M003 MODIFICATION NOTE 3  
(for Electronics Technicians)

SUBJECT : SixPakPlus Multifunction Board Installation

PURPOSE : Improve the M003 microcomputer system reliability.

EQUIPMENT AFFECTED: M003 Microcomputer System

Figure 3A

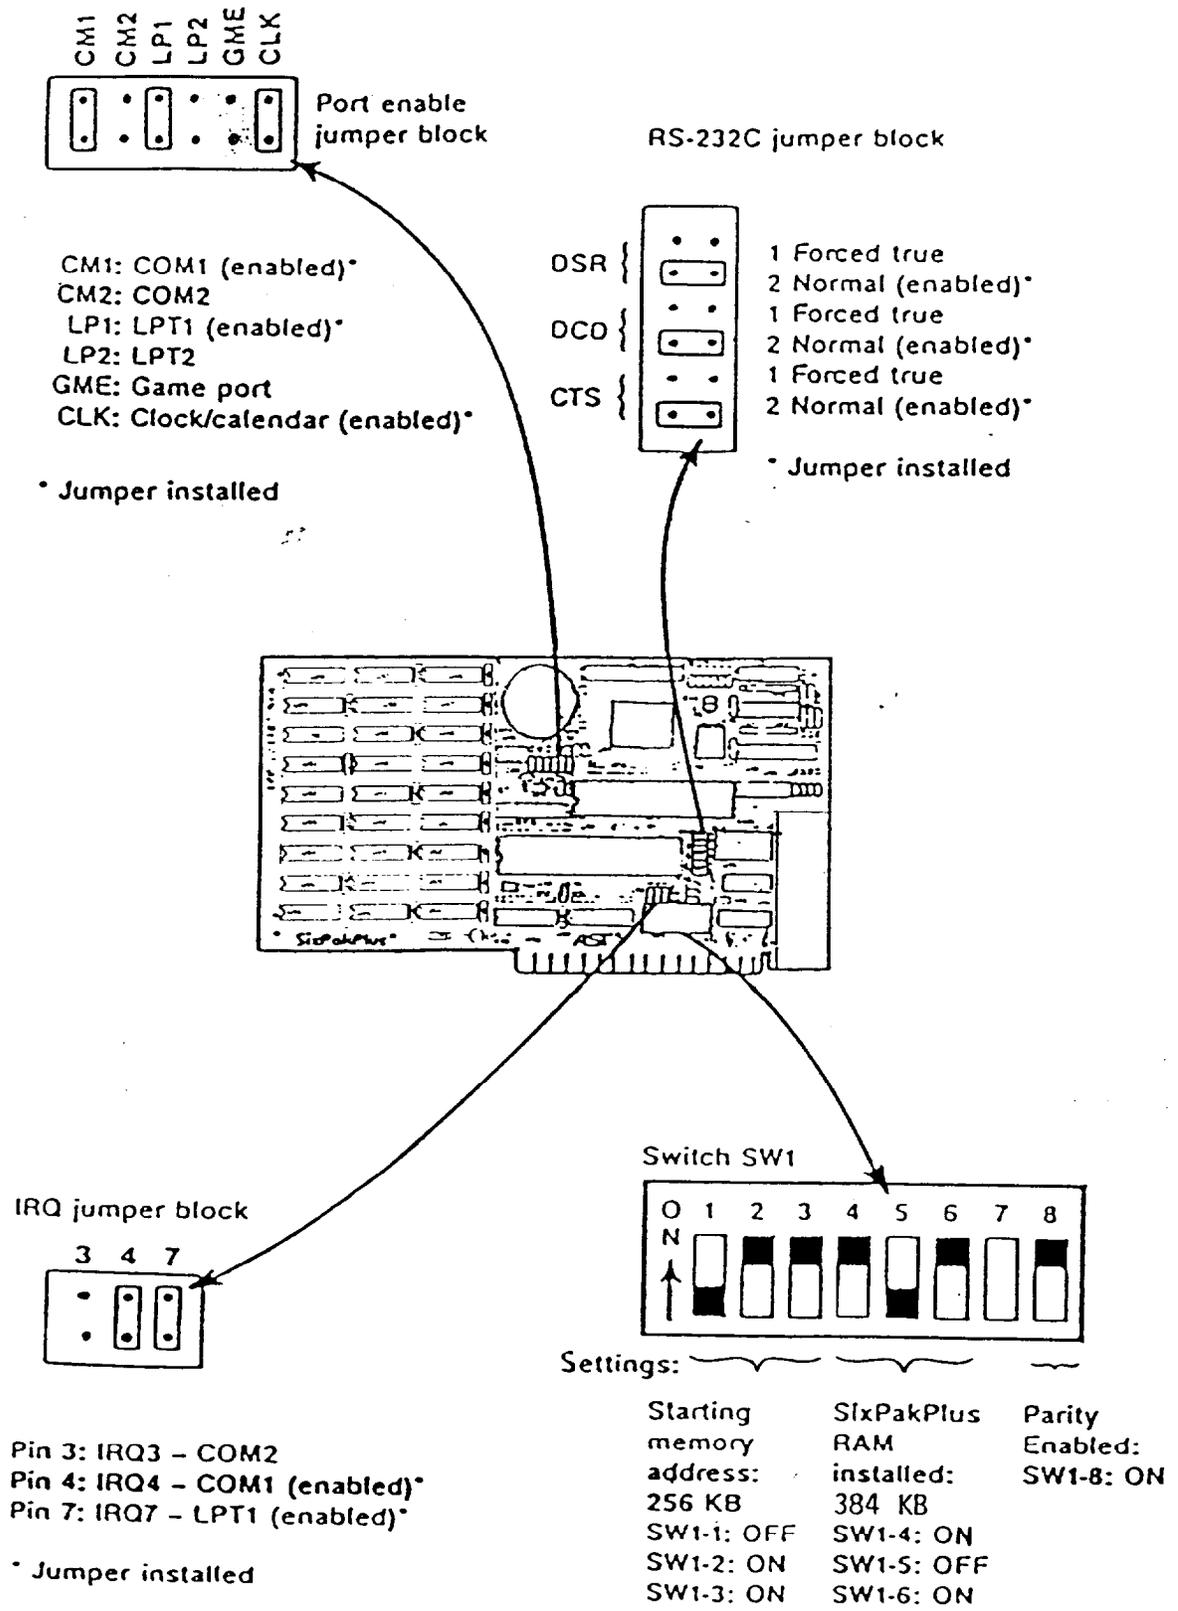
If you receive a short board, refer to figure 3A and verify the switch settings and jumpers.

NOTE: If S1 switch settings are wrong, the amount of memory enabled on the multifunction board will be incorrect. This will cause an erroneous memory countup during the power on self test and intermittent system operation.

Figure 3B

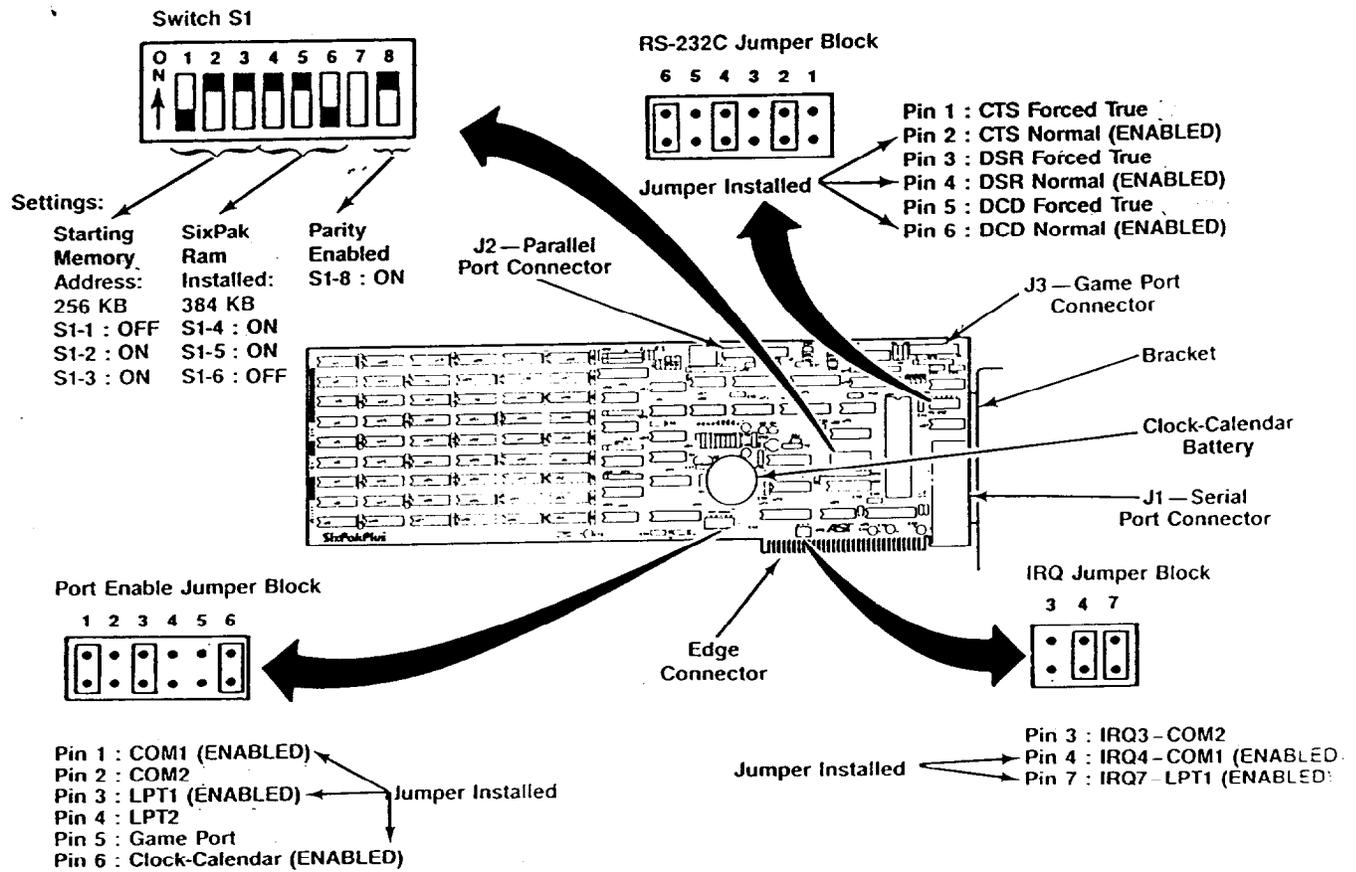
If you receive a full length board, refer to figure 3B and verify the switch settings and jumpers.
